## **Planning Commission December 13, 2018 Meeting: 8.1**

### **Marketplace Final Development Plan - Parcel B (Office and Garage)**

***Applicant:***            ***City Center Realty Partners***

***Architect:***           ***Hart / Howerton***

2. EAST ELEVATION - FACING TRAIN TRACKS - NORTH PORTION

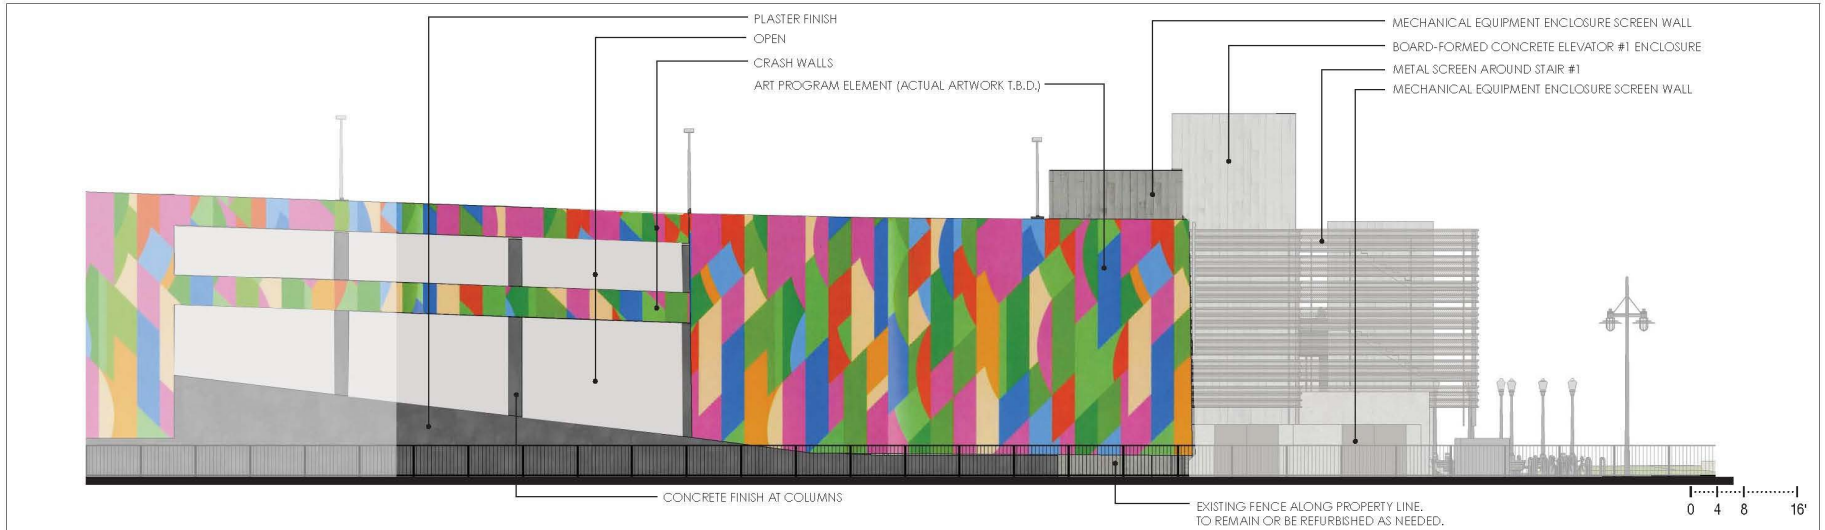
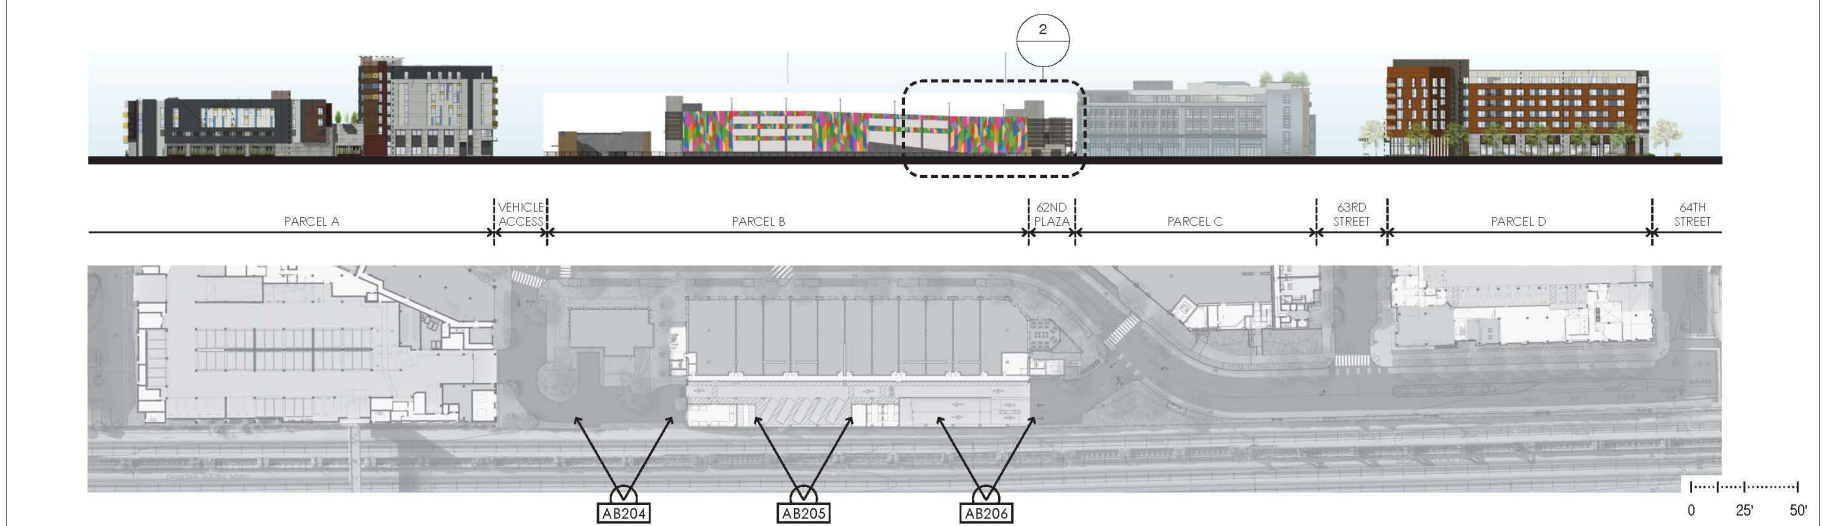
-- DA allows the use of public art funds for the building's east elevation. The proposal now includes public art on all four elevations including Shellmound Street

-- To the extent east elevation are intended to satisfy public art requirement, they are not subject to Commission approval; however any façade treatment that is not part of the public art program will need Commission approval
